**National Highways Planning Response (NHPR 21-09)  
Formal Recommendation to an Application for Planning Permission**

**Council's Reference:** LCC/2021/0007

**Location:** Land north of the A674 Millennium Way, north east of M61 Junction 8

**Proposal:** Prior extraction of sand / gravel and subsequent restoration with inert engineering fill to facilitate a platform for employment development or agriculture with peripheral landscaping

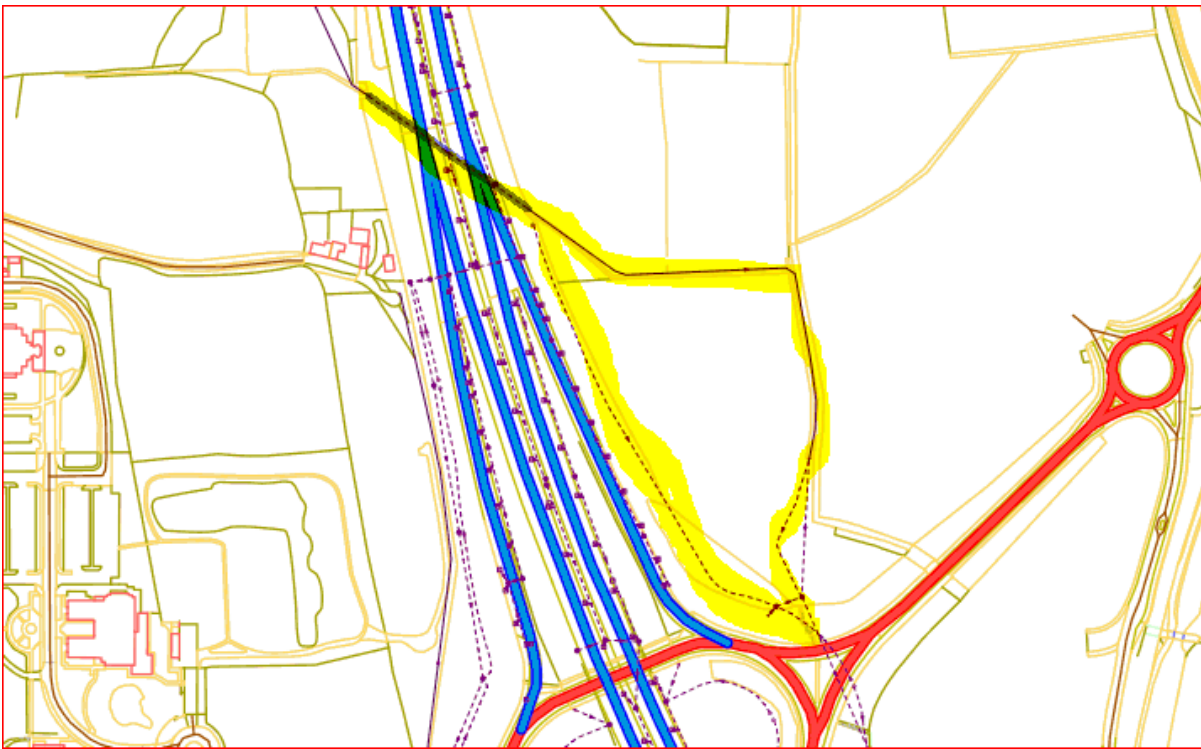
A motorway filter drain runs along the motorway boundary with this site at the foot of the motorway embankment., as shown in the drawing below. **Again, there will need to be a level of standoff agreed with National Highways from the excavation to ensure that this drain is not disturbed.**

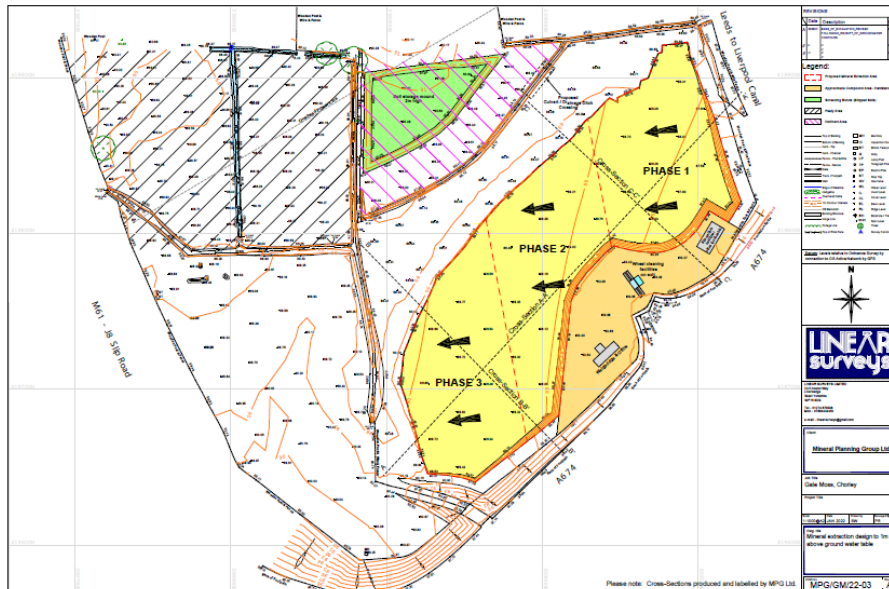
- Drawing reference MPG/GM/22-03, submitted with the planning application originally, shows the extent of mineral extraction across the site. This drawing, which is also included in the Analysis of Slope Stability and the Supporting Statement, shows the proposed extraction is well away from the M61.

However, other drawings included as part of the Plan submission such as MPG/GM/DEC20-04 and MPG/GM/DEC20-01 (attached for ease of reference) show the excavations to extend close to the M61 boundary.

Lancashire County Council (as the planning authority) have since confirmed to us that the physical extent of the development has been reduced from that proposed with the application originally, and is that shown in drawing reference MPG/GM/22-03 Rev A (extract copied below)

As no mineral extraction work will not be taking place close to the motorway boundary, we are satisfied that there is no need for any slope stability analysis.
